CITY OF ST. HELENS PLANNING DEPARTMENT

MEMORANDUM

RE: Architectural Character Review at 325 Strand Street

DATE: August 26, 2024

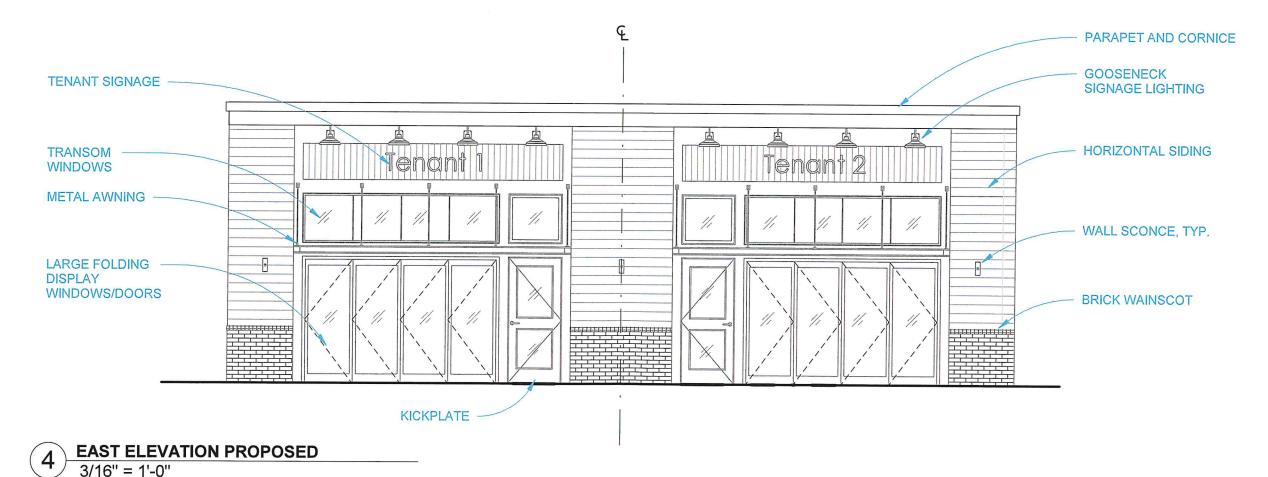
The Guidelines encourage preserving original windows. It appears the applicant will be replacing all of the original Strand Street windows with new transom windows and large folding display windows/doors in lieu of traditional storefront windows with kickplates/bulkheads. The large folding display windows are not necessarily traditional and do not incorporate a window kickplate. Two neighboring traditional storefront photos/plans are included on the next page for reference. Does the Commission want to recommend a change to the large folding display windows/doors to mirror a more traditional storefront window that would match the adjacent two developments?

The existing building does not have any historical value, and the existing windows are single pane and fully deteriorated or broken. Instead, an interpretation of the architectural guidelines and the concept of the existing layout will be pursued. The overall pattern of each tenant entrance (door and window) is a rectangular shape, the same idea applies to the building alteration by having the entrance door to one side, and the large folding display windows/doors to the other side. This creates a visual connected rectangle at the pedestrian level, similar to the architectural guideline layout. The existing building has transom windows that run across the display windows and tenant door that is also evident in the building alteration. Together, the display windows, entry door (with kickplate), and the transom windows represent the ethos of the Olde Towne guidelines without mimicking the design exactly.
